Proposal for Parallel SCSI: Increase Transfer Rate and Improve Error Detection

To: T10 Technical committee
From: Jim McGrath
Quantum Corporation
500 McCarthy Boulevard
Milpitas, CA USA 95035
Phone: 408-894-4019
Fax: 408-952-3620
Email: jim.mcgrath@quantum.com
Date: ~~June 2~~May 19, 1998

Rev 1

Figure xxx: CRC_AVAILABLE and Data Group fields for DATA IN

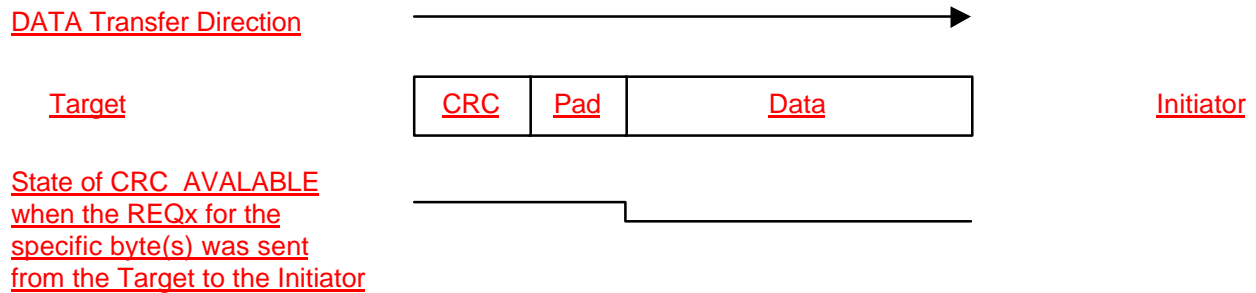
If the I/O signal is true (transfer to the initiator), the target shall first drive the DB(7-0,P), DB(15-0,P,P1), or DB(31-0,P,P1,P2,P3) signals to their desired values. If the target wishes to send pad field or CRC field byte(s) for the current data ~~group frame~~ (see clause xxx), then the CRC_AVAILABLE signals (P and P2) shall be asserted, the DATA BUS (DB7-0, DB15-0, DB(P1), DB31-0, DB(P3)) shall contain the pad field or CRC field information. Otherwise the CRC_AVAILABLE signal shall be negated.

Figure xxx: CRC_AVAILABLE and Data Group fields for DATA OUT

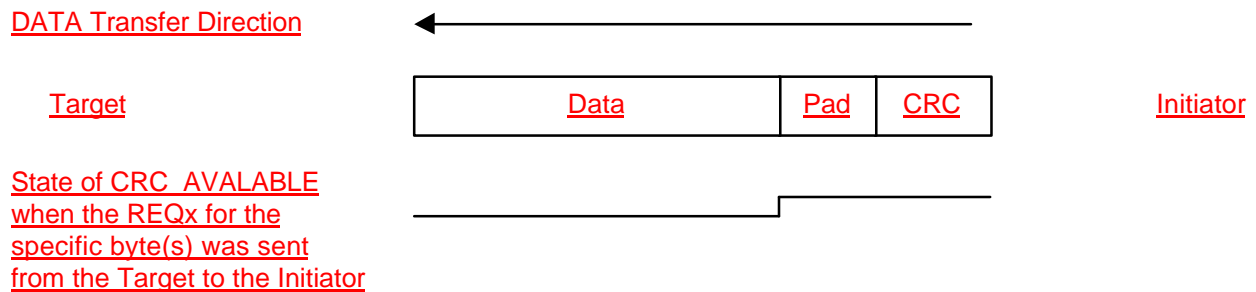
If the I/O signal is false (transfer to the target), then after detecting a REQx transition, the initiator shall first drive the DB(7-0), DB(15-0,P1), or DB(31-0,P1,P3) signals to their desired values. As byte(s) are transferred from initiator to target, the REQx transition that was received in order to allow the data transfer shall be the first transition received and not already used to allow a previous data transfer from the initiator to the target. The initiator shall remember whether each REQx transition was received with CRC_AVAILABLE asserted or with CRC_AVAILABLE negated. When a REQx transition that was received with CRC_AVAILABLE asserted is used to allow a data transfer from the initiator to the target, the information transferred shall be from the pad field or CRC field bytes for the current data groupframe.

Figure 2 -- CRC_AVAILABLE timing

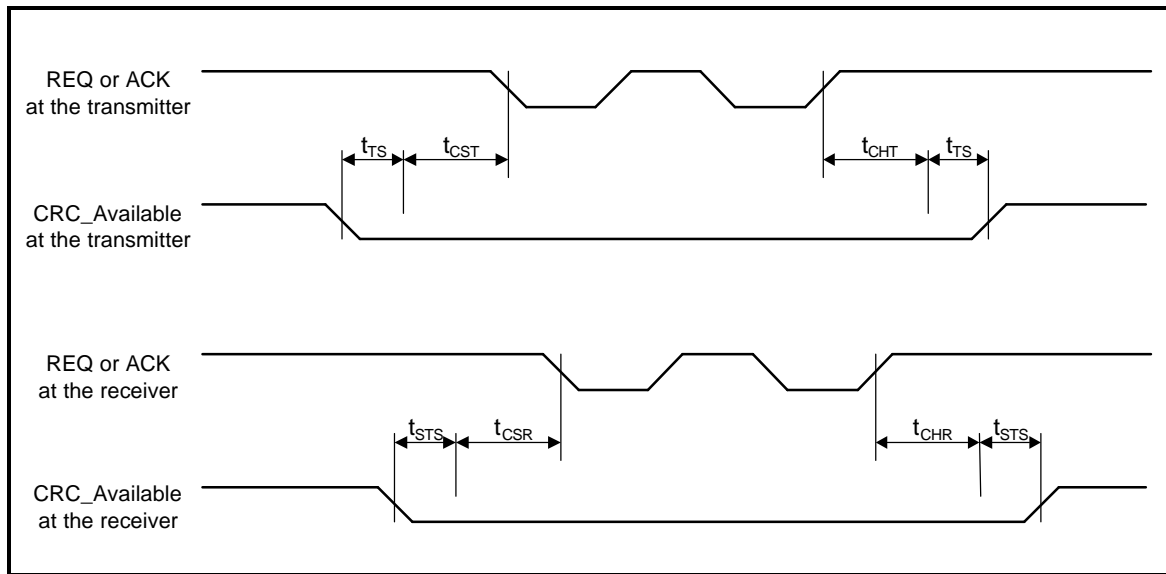
[Note: in the second t_{sts} , there should be additional setup time to allow CRC_AVAILABLE to transition. Following the precedence for setup to CRC_AVAILABLE, it is suggested that an extra 10 ns setup be added here.]
